Item Name: Quick Release Heli-Utility-Basket™ Long, HD Lid, Spacepod™/Squirrel Cheek Comp.

DART SERVICE INSTRUCTION

TO AMEND INSTALLATION INSTRUCTIONS D350-607-3 Rev.D,
INSTALLATION INSTRUCTIONS D350-607-4 Rev. C AND
INSTRUCTIONS FOR CONTINUED AIRWORTHINESS ICA-D350-607 REV. 6

A	NEW ISSUE	AJS	14.05.16
REV.	DESCRIPTION	BY	DATE
DESIGN	AJS	DART AEROSPACE LTD	
DRAWN	AJS	HAWKESBURY, ONTARIO, CANADA	
CHECKED	N/A	DRAWING NO.	REV. A
MFG. APPR.	N/A	DSI 9699	SHEET 1 OF 2
APPROVED		TITLE	SCALE
DE APPR.		LUG REPLACEMENT	NTS
DATE	14.05.16	COPYRIGHT © 2014 BY DART AEROSPACE LTD THIS DOCUMENT IS PRIVATE AND CONFIDENTIAL AND IS SUPPLIED ON THE EXPRESS CONDITION THAT IT IS NOT TO BE USED FOR ANY PURPOSE OR COPIED OR COMMUNICATED TO ANY OTHER PERSON WITHOUT WRITTEN PERMISSION FROM DART AEROSPACE LTD.

FIGURE 1: INSTALLATION OF D4775-041 FWD STRUT

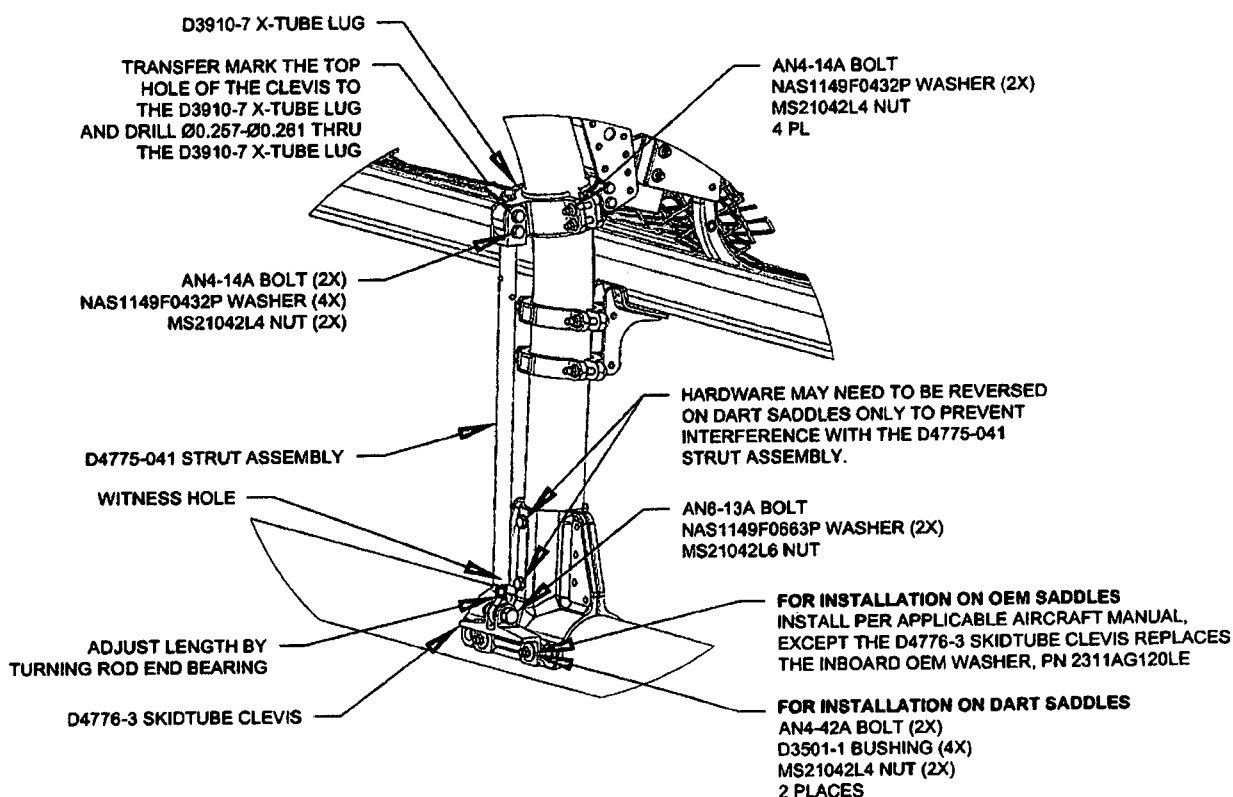
- 3.1 Substitute the Forward Lower D3910-5 X-Tube Lug with the D3910-7 X-Tube Lug as shown in Figure 1.
- 3.2 Install the forward D4775-041 Strut Assembly. Transfer mark from the upper hole on the clevis of the D4775-041 Strut Assembly to the D3910-7 X-tube Lug and drill thru the lug $\varnothing 0.257$ - $\varnothing 0.261$ as shown in Figure 1. Touch up chemical conversion coating per MIL-DTL-5541. Check the witness holes located at the bottom end of the D4775-041 Strut Assemblies to ensure that the thread from the rod end extends past the witness hole.
Torque MS21042L4/-4 nuts to 50-70 in-lbs (5.7-7.9 N-m). Torque MS21042L6/-6 nuts to 160-190 in-lbs (18.1-21.5 N-m).
- 3.3 Complete the installation in accordance with Installation Instructions D350-607-3 Rev. D or D350-607-4 Rev. C.
